# 8-10 New McLean Street

## Urban Design Study

**Prepared for**  
DPHI

**Issued**  
June 14 2024

Envelope Development  
Solar Compliance

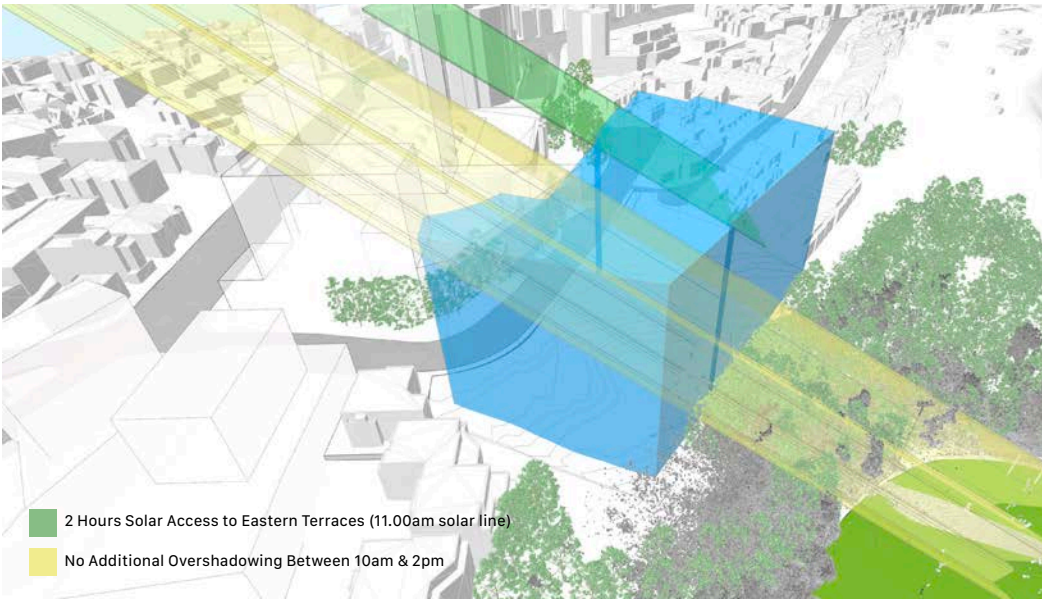
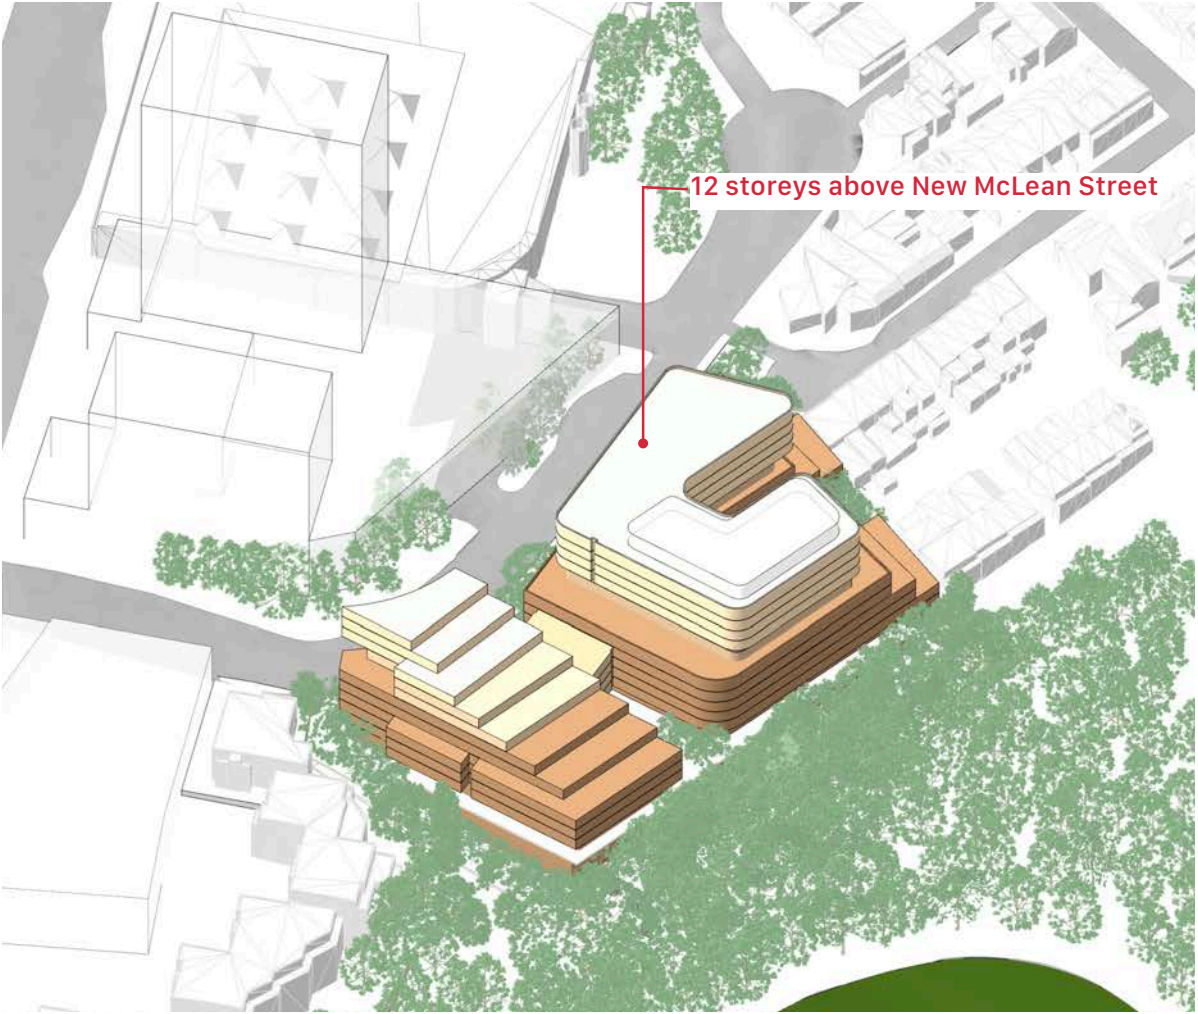
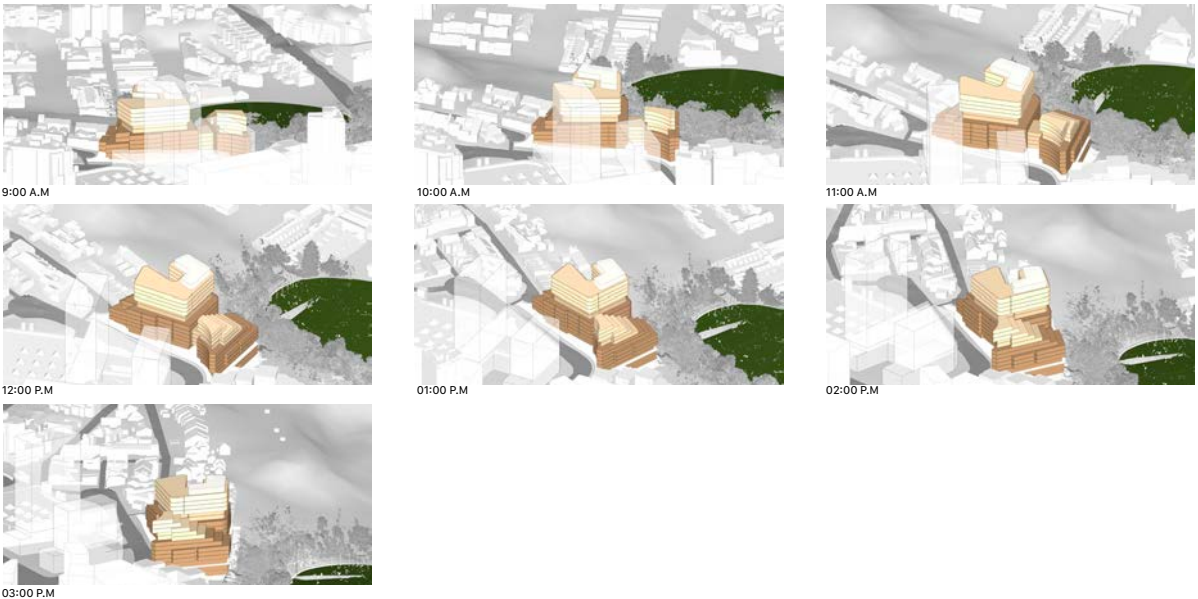
In review of the proponents response to the Strategic Planning Panel’s recommendations and design principles, we have made the following observations:

- The zero setback from the southern terrace houses raises concerns for interface and retention of existing significant trees along the south-eastern boundary
- a 12m separation between floors above 4 storeys on the southern mass would be difficult to achieve ADG compliance and for provision of residential amenity, the depth and shape of the footprints, in particular the podium levels of the south- eastern block, may be difficult to achieve an efficient layout and may also compromise residential amenity.
